**ATTACHMENT 11**

**REVISED RADIOLOGICAL EMERGENCY PLAN  
ANNEX INFORMATION**

**THREE MILE ISLAND NUCLEAR STATION**

**EP-AA-1009**

**RECOGNITION CATEGORY**  
**FISSION PRODUCT BARRIER DEGRADATION**  
**Figure 3-F-1: PWR Containment Integrity or Bypass Examples**

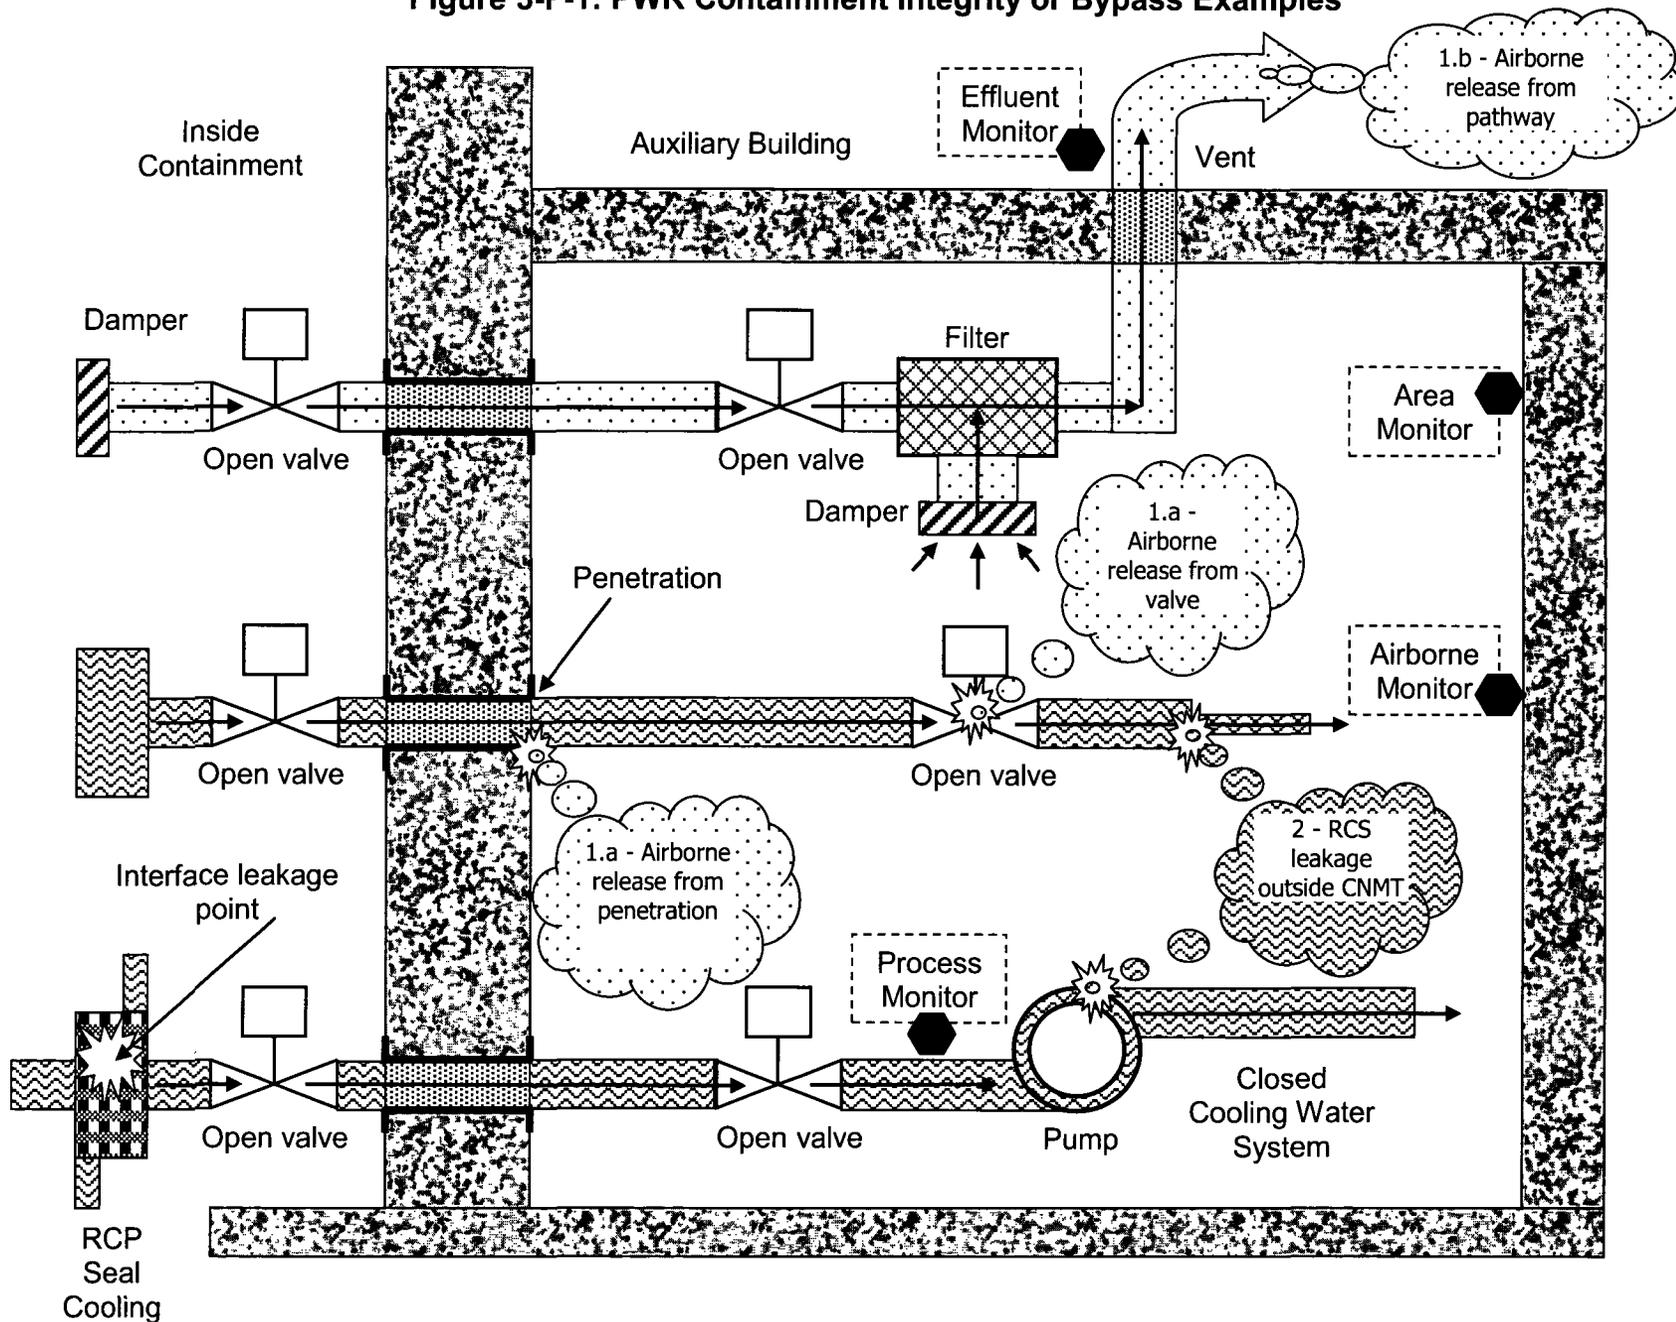
- ~~a. UNPLANNED lowering in containment pressure or rise in radiation monitor readings outside of containment in the Emergency Directors judgment indicate a loss of containment integrity.~~

1. Containment isolation is required and **ANY** of the following:
  - a. UNPLANNED lowering in containment pressure following initial pressure rise  
**OR**
  - b. Containment pressure or water level response not consistent with LOCA conditions.  
**OR**
  - c. UNISOLABLE pathway from containment to the environment exists.

1.b - Conditions are such that there is an UNISOLABLE pathway for the migration of radioactive material from the containment atmosphere to the environment. As used here, the term "environment" includes the atmosphere of a room or area, outside the containment, that may, in turn, communicate with the outside-the-plant atmosphere (e.g., through discharge of a ventilation system or atmospheric leakage). Depending upon a variety of factors, this condition may or may not be accompanied by a noticeable drop in containment pressure.

Refer to the top piping run of Figure 3-F-1. In this simplified example, the inboard and outboard isolation valves remained open after a containment isolation was required (i.e., containment isolation was not successful). There is now an UNISOLABLE pathway from the containment to the environment.

Leakage between two interfacing liquid systems, by itself, does not meet this threshold. Refer to the bottom piping run of Figure 3-F-1. In this simplified example, leakage in an RCP seal cooler is allowing radioactive material to enter the Auxiliary Building. The radioactivity would be detected by the Process Monitor. If there is no leakage from the closed water cooling system to the Auxiliary Building, then no threshold has been met. If the pump or system piping developed a leak that allowed steam/water to enter the Auxiliary Building, then loss threshold 2 would be met. Depending upon radiation monitor locations and sensitivities, this leakage could be detected by any of the four monitors depicted in the figure and cause threshold 1.a to be met as well.
